# Abbot Point Anchorage Proposal

## Results of Consultation

<b>Prepared by</b>	Joanne McGraw
<b>Title</b>	Business Officer (Vessel Traffic Management)
<b>District &amp; Region</b>	Brisbane
<b>Branch &amp; Division</b>	Maritime Safety Queensland
<b>Project/program</b>	Implementation of dedicated ship anchorages at Abbot Point
<b>Project number</b>	
<b>Project location</b>	
<b>Status</b>	Final
<b>DMS ref. no.</b>

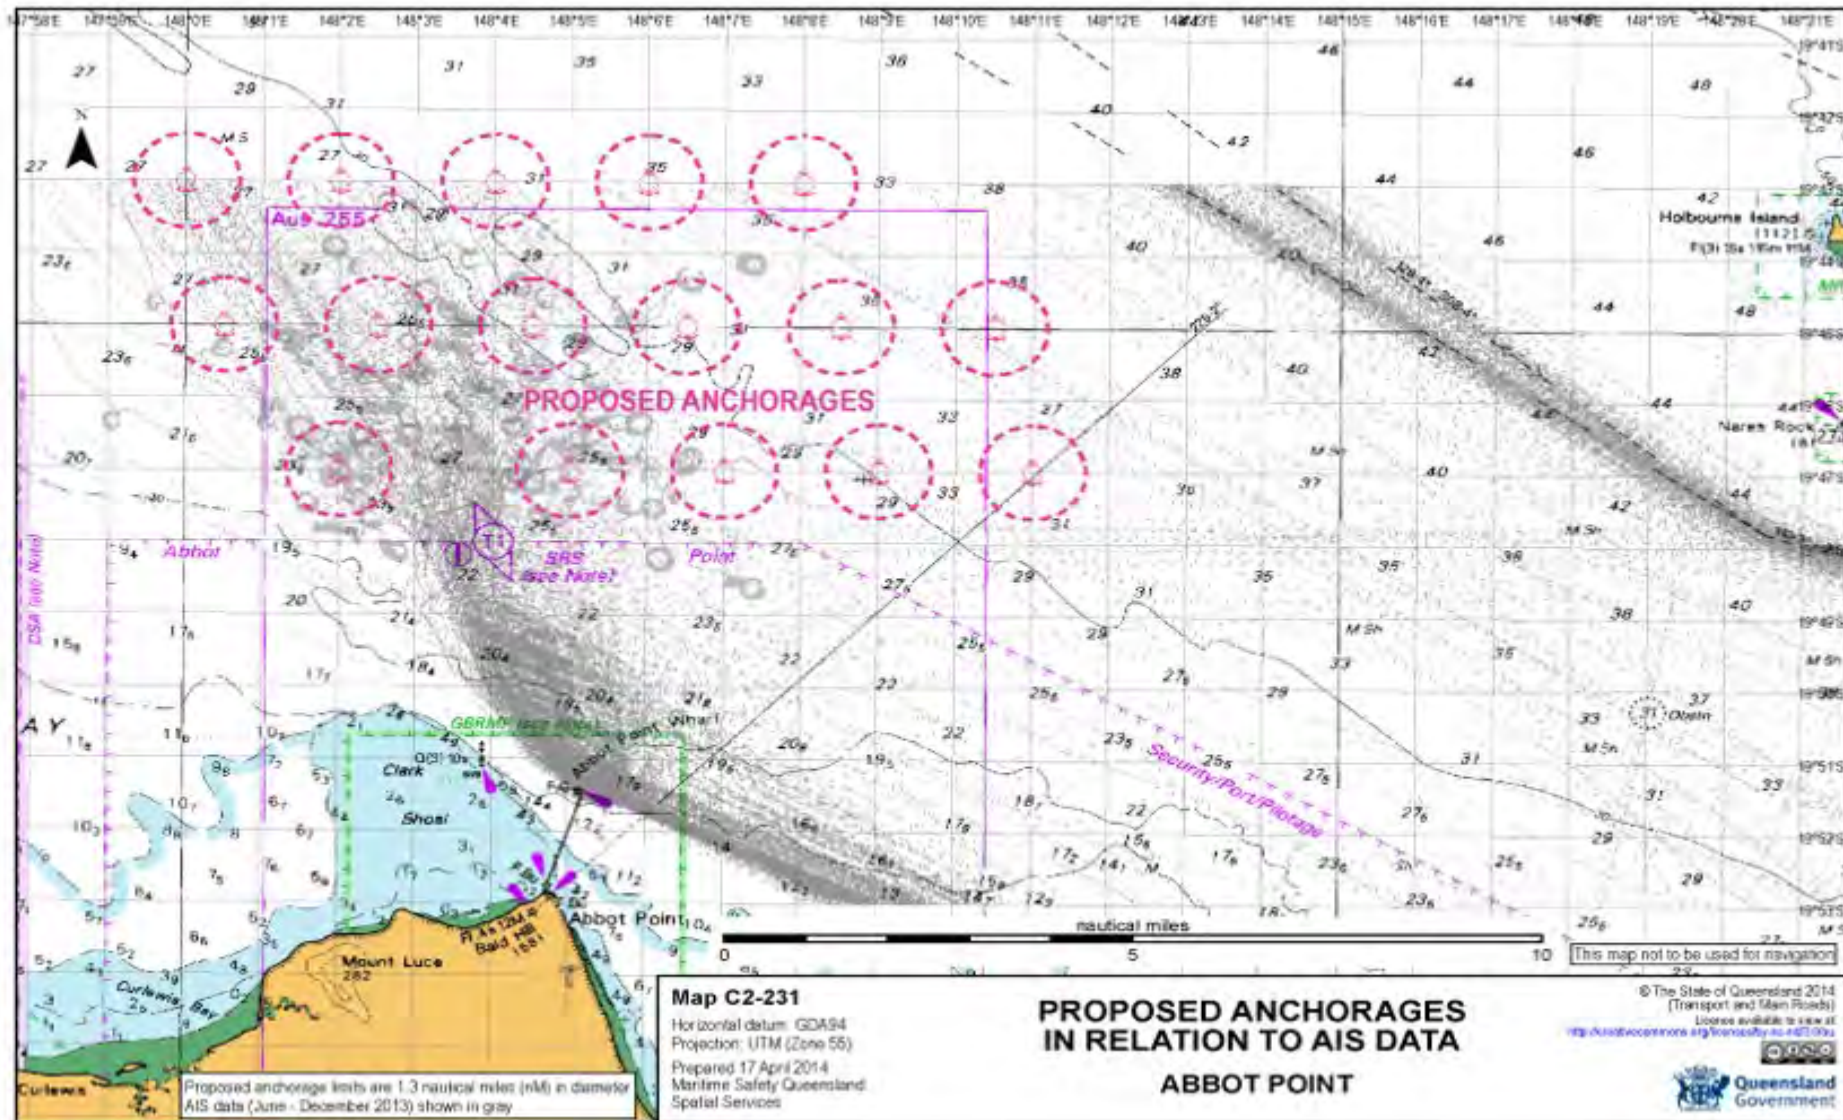
- *The preferred option is to utilise the deeper anchorages (i.e. the most easterly positions) first. This would minimise the impacts to the more productive fishing grounds, keeping the anchored ships further away from working fishing vessels.*

- *It would be best to have a wider separation between the anchorages as this would provide increased ease and safety for trawl operations to continue fishing between ships at anchor.*

- *Most heavily used anchorages should be the ones that carry the lowest risk of the range of impacts under consideration and proposed for consideration.*

MSQ has removed all anchorages that are within the 30m contour. VTS will direct vessels to the seaward 2 rows and only use the inner row (closest to the 30m contour) if required.

The revised design provides for between 1.2 to 1.6 nm from a 2-cable arc of the centre of each anchorage. Given the technology and experience of Trawler Master's this is adequate clearance to safely trawl between ships and keep well clear of the anchor divots which are expected to be confined to around the centre of the anchorage circle.

VTS will direct vessels to the seaward 2 rows and only use the inner row (closest to the 30m contour) if required.

# Appendix B – Revised anchorage design from 2015 consultation

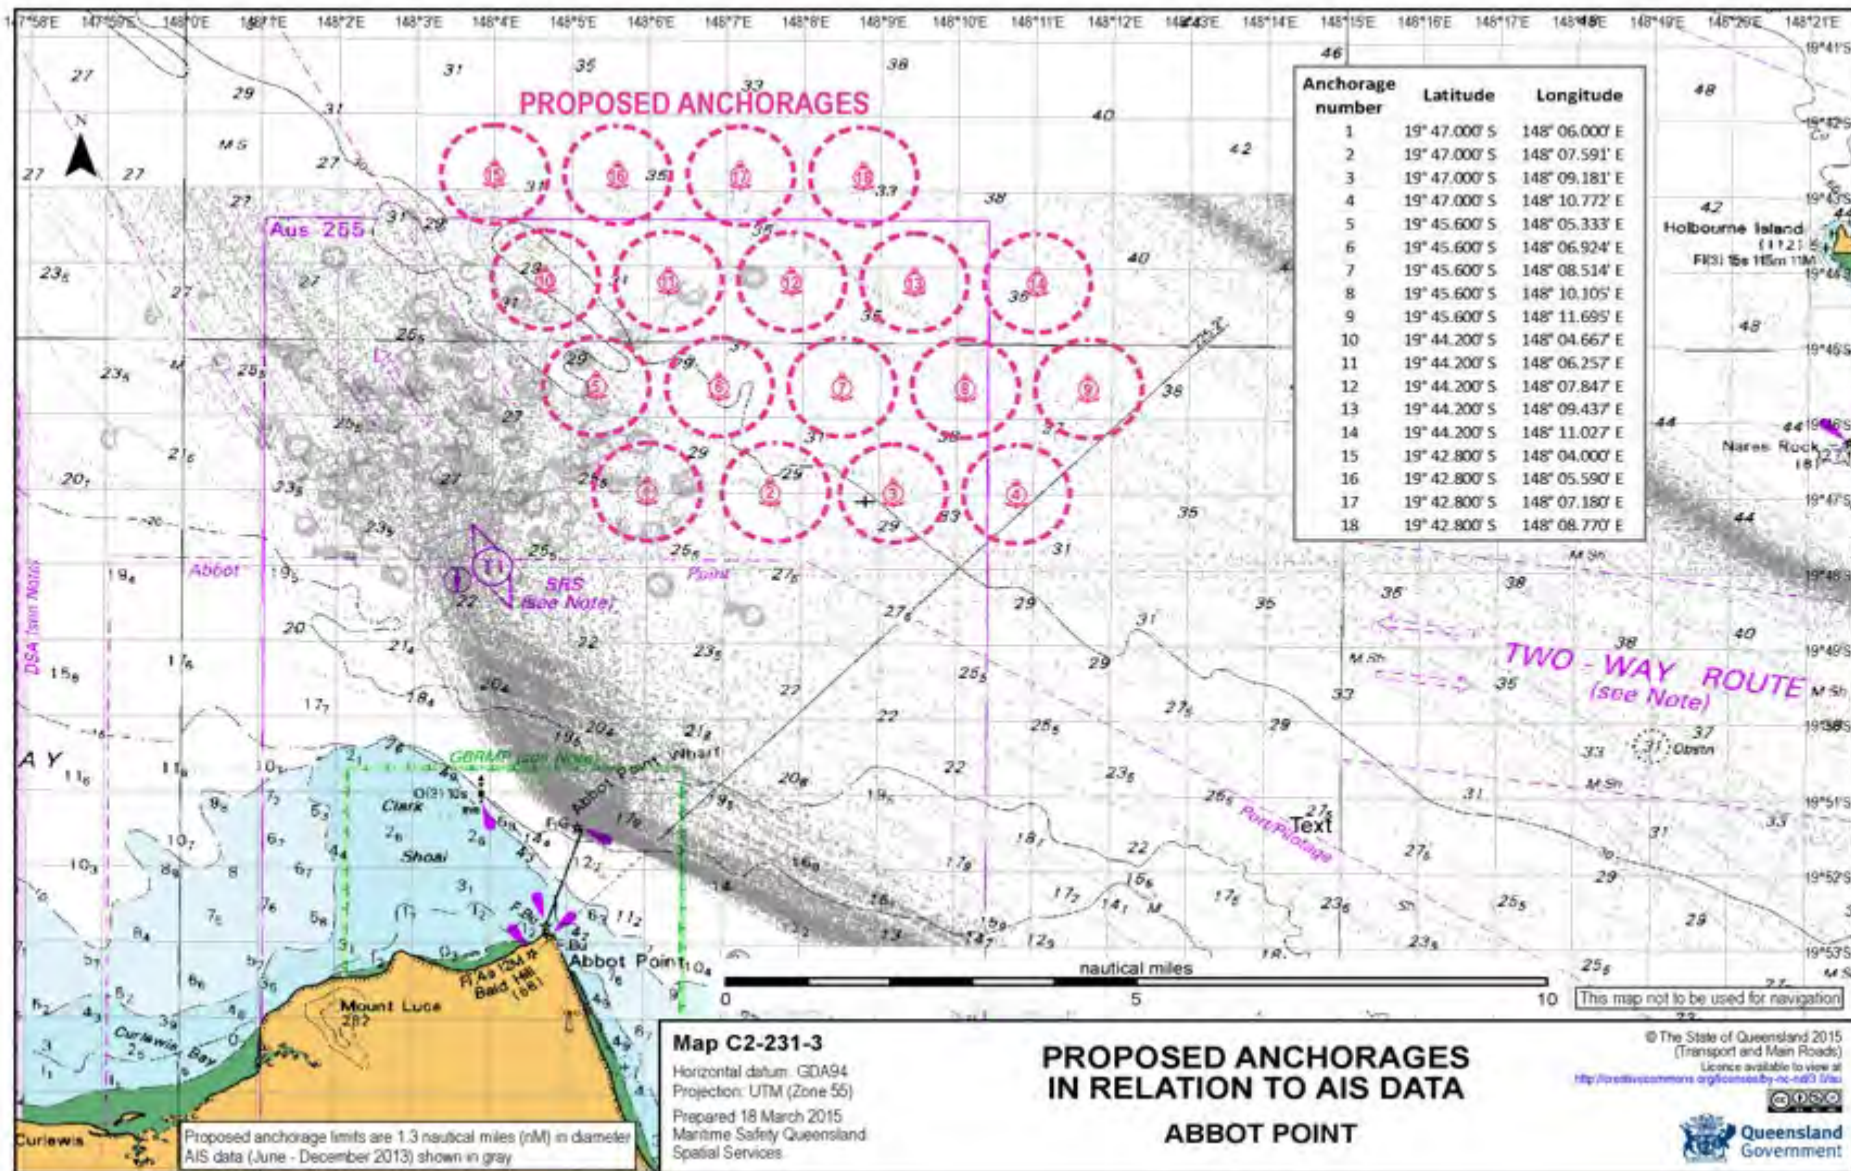
- minimise the overall footprint as much as possible
- constrain to those already most disturbed and with least environmental impact
- minimise effect on trawl fishing
- fishermen to retain access
- no anchorage within proposed two-way route

Based on feedback from stakeholders the initial design was amended to minimise the overall footprint of the anchorage. The location of the anchorage area was also moved slightly to the east so that it does not encroach on fishing effort grid L22 or on the charted two-way route's northern approach to the port. This resulted in the revised anchorage design shown at Appendix B.

# Appendix C – Proposed anchorage design 2019

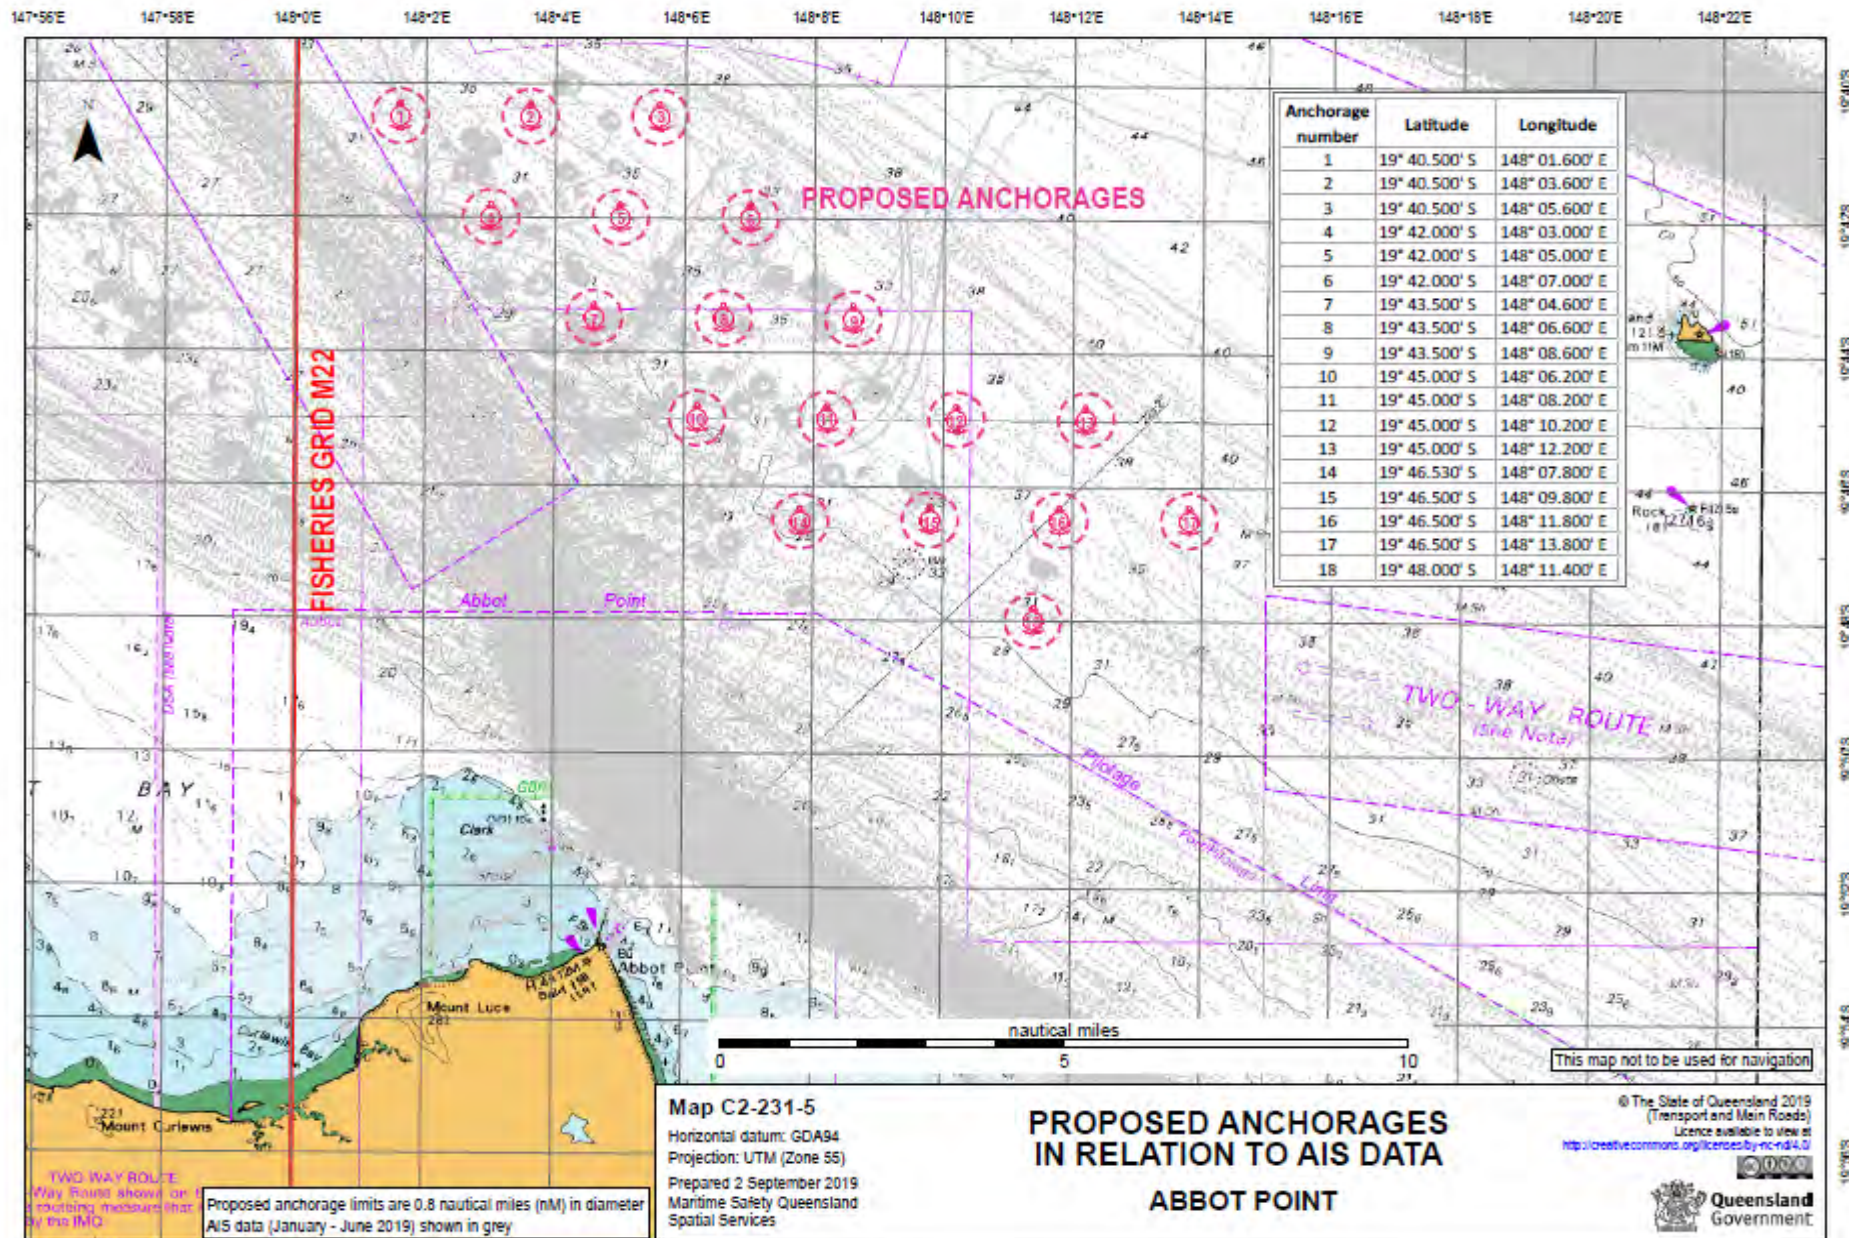
MSQ has revisited the 2015 proposed designated anchorages, reviewed the consultation and amended the proposed configuration of the anchorages to further accommodate suggestions, namely;

The revised design layout is shown at Appendix C. This is the anchorage layout being proposed.
